# City of Richmond

## **Report to Committee**

RZ 09-453123

PAUL GOODWIN (GBL ARCHITECTS) has applied to the City of Richmond for permission to rezone 9340, 9360 and 9400 Odlin Road from Single Detached (RS1/F) to Low Rise Apartment (ZLR24) Alexandra Neighbourhood (West Cambie) to develop 221 Apartment Units, including 10 Affordable Housing

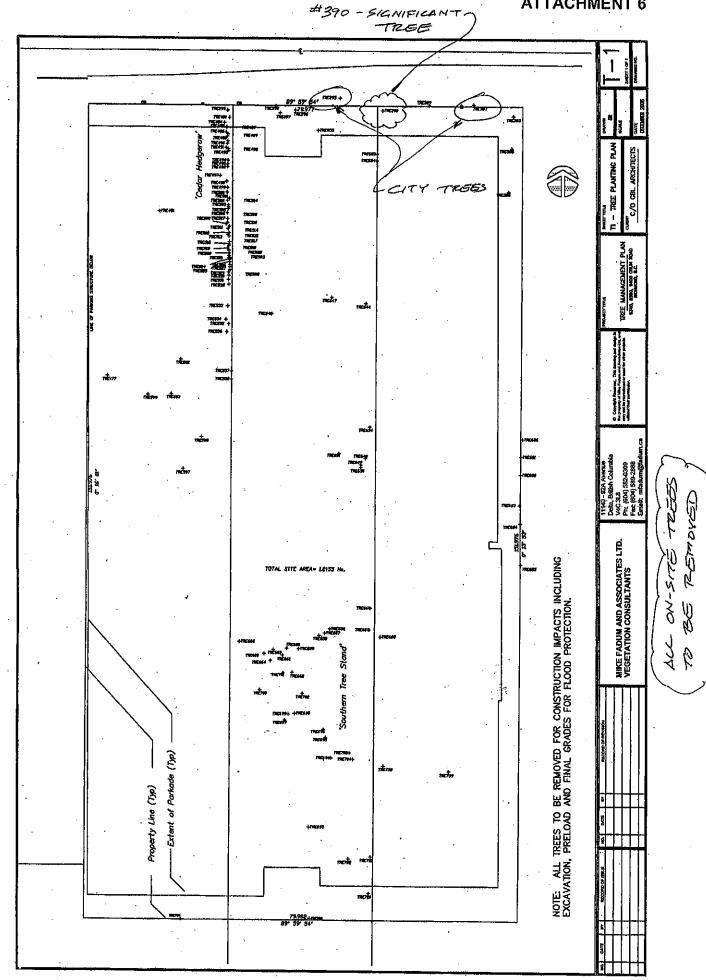
- 3. design development to improve central open space design, programming, and adjacencies. Provide play opportunities for young children with either play equipment or alternative feature. Create useful open spaces. Consider relationship of indoor and outdoor amenity areas, including ramped access; GBL: See architects comments above.
  - SLA: Landscape areas have been reduced and replaced with common patio areas adjacent the amenity rooms. Large gathering patios adjacent amenity rooms are juxtaposed with smaller niche sitting areas (some in lawn, some paved) to offers user variety. Lawn areas for sitting and passive use have replaced a previously proposed dense plantings.

Children's play area has been integrated in central circular area. A climbing mound with a slide in a forest of Trembling Aspen grounds the central portion of that area. Benches have been tucked into the mound as well as on the edges of walkway that circles inner area □places for parents and or passerby to sit. A curvilinear wall encapsulates that inner space and a series of quadrants within that circle features 3 main play areas which are:

- 1) Climbing wall
- 2) sand area with faux fossil structures for discovery play
- 3) water spigots and sand/gravel area for building and play using the elements of water and sand.

A circular track encapsulates the outside of the circle for tricycles. In short the central play area multi tasks as a piece of play art when not in use by children the passerby can sit relax and feel like they are part of a common outdoor space.
